RE: Hotel Albuquerque NW Parking Lot
2000 Bellamah Ave NW
Grading Plan
Engineer's Stamp Date: 3/7/18
Hydrology File: J13D066

Based on the information provided in your submittal received on 3/7/18, this plan cannot be approved for Grading or Paving Permit until the following are corrected:

DRAINAGE PLAN

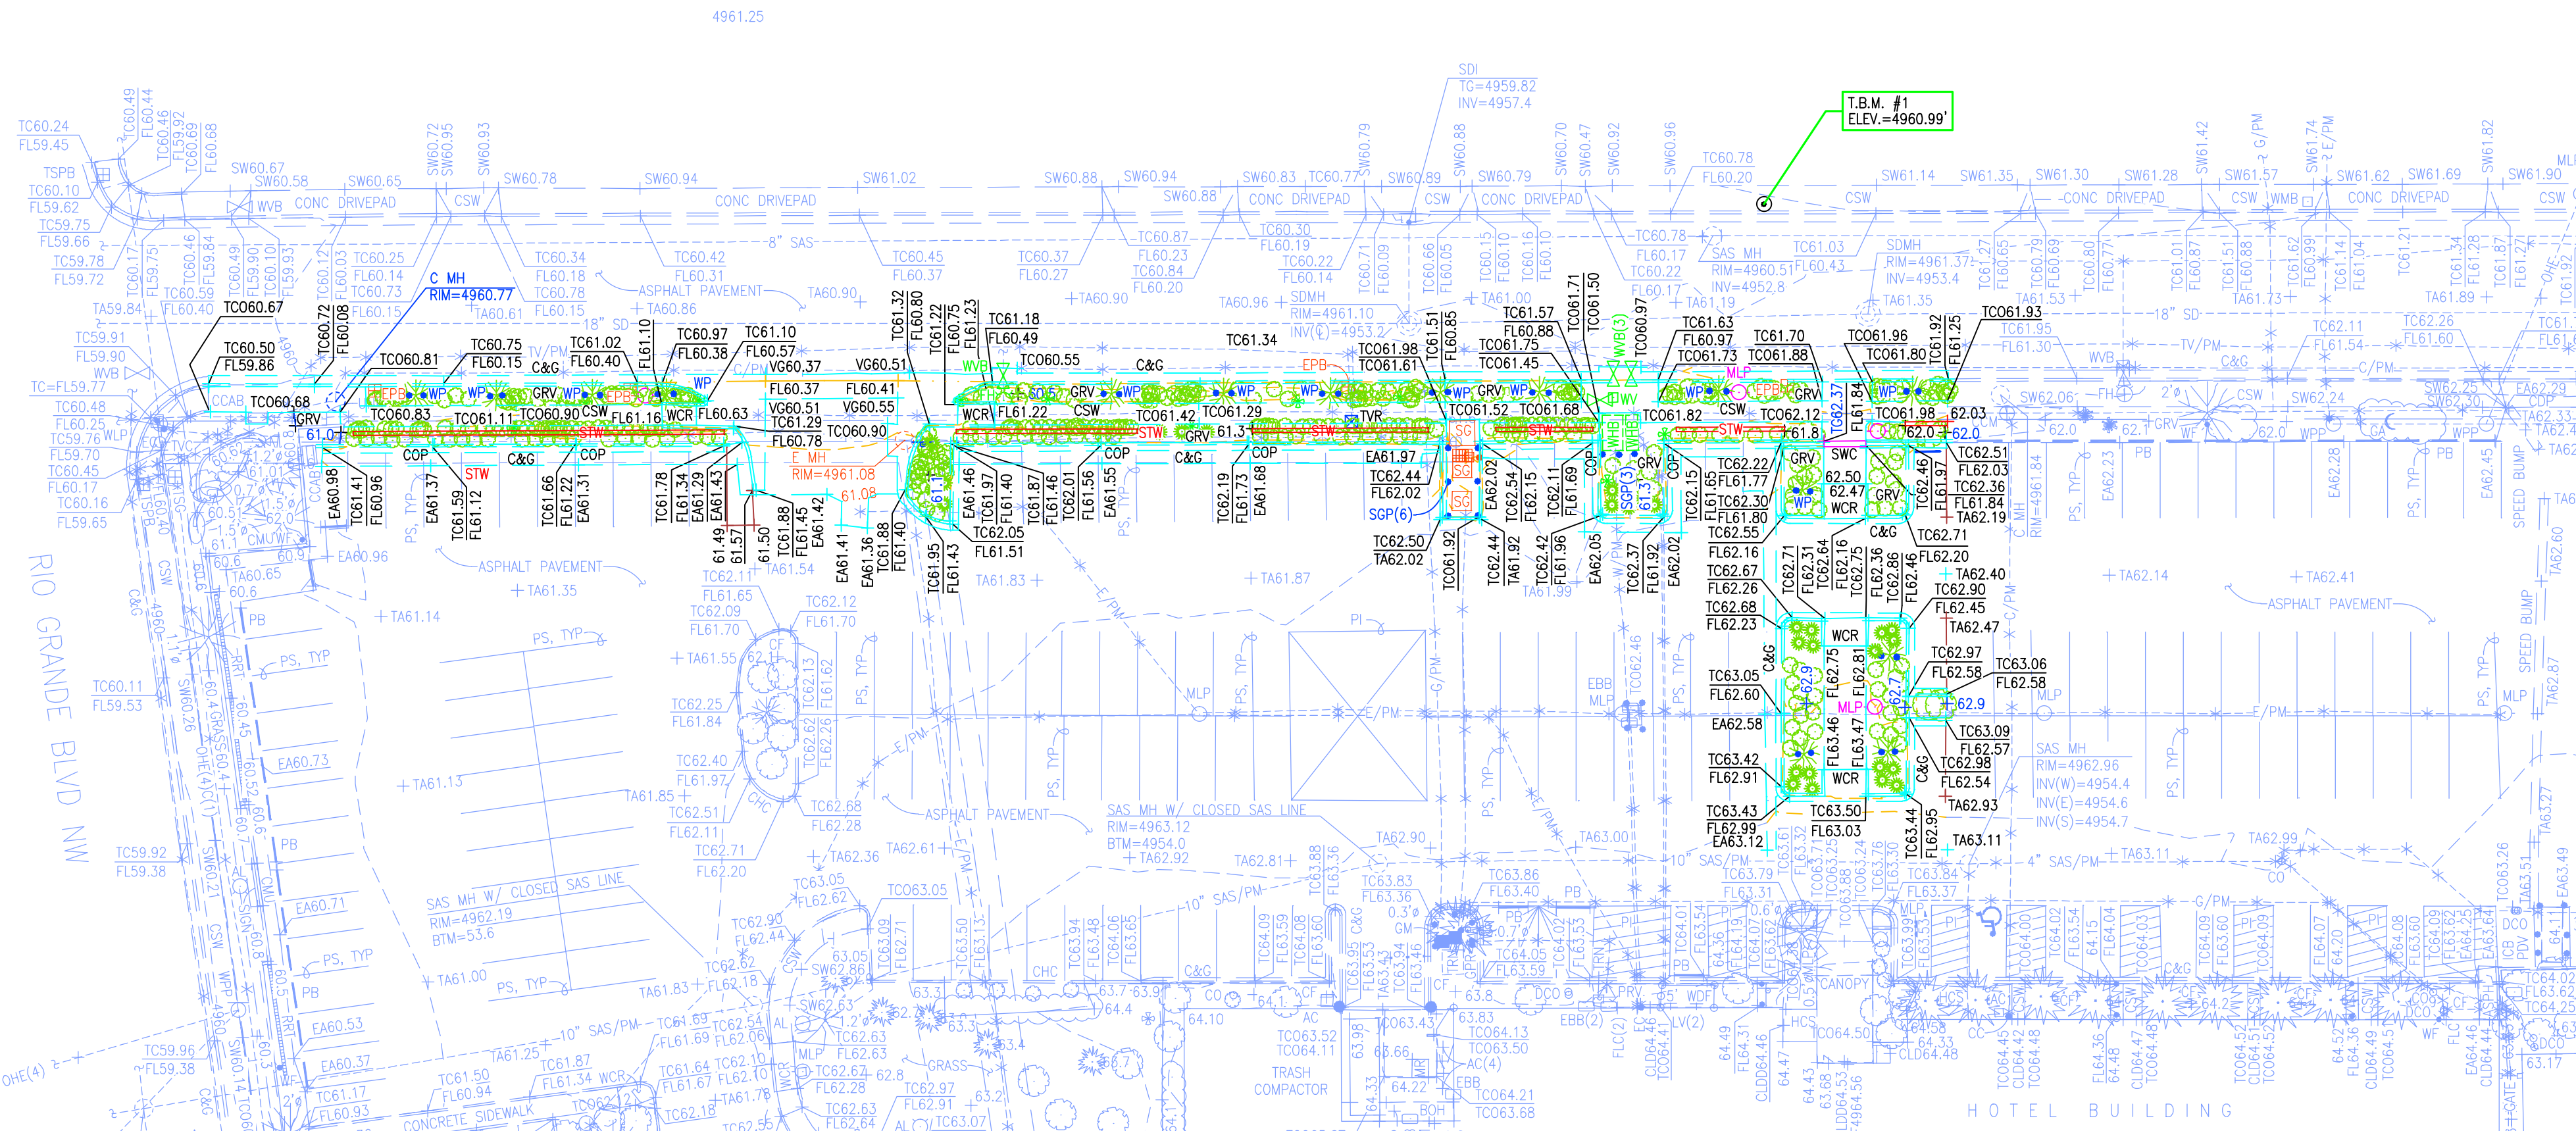
1. Each pond needs to be sized for the impervious area draining to it. Many of the ponds are undersized for the impervious area draining to them and one pond is oversized, but receives very little runoff (Area1 Pond). Can more runoff be directed into the Area1 Pond to meet the requirement?

2. Please recheck the first flush requirement calculation. For redevelopment, it should be calculated as $\text{Volume} = 0.26''/12 \times 44,302\text{SF}$.

3. Quantify the volume of first flush runoff that bypasses the first flush ponds and state on plans.
4. If the first flush runoff cannot be retained onsite, payment of fee-in-lieu will be required for the bypass amount at a rate of \$8/CF.
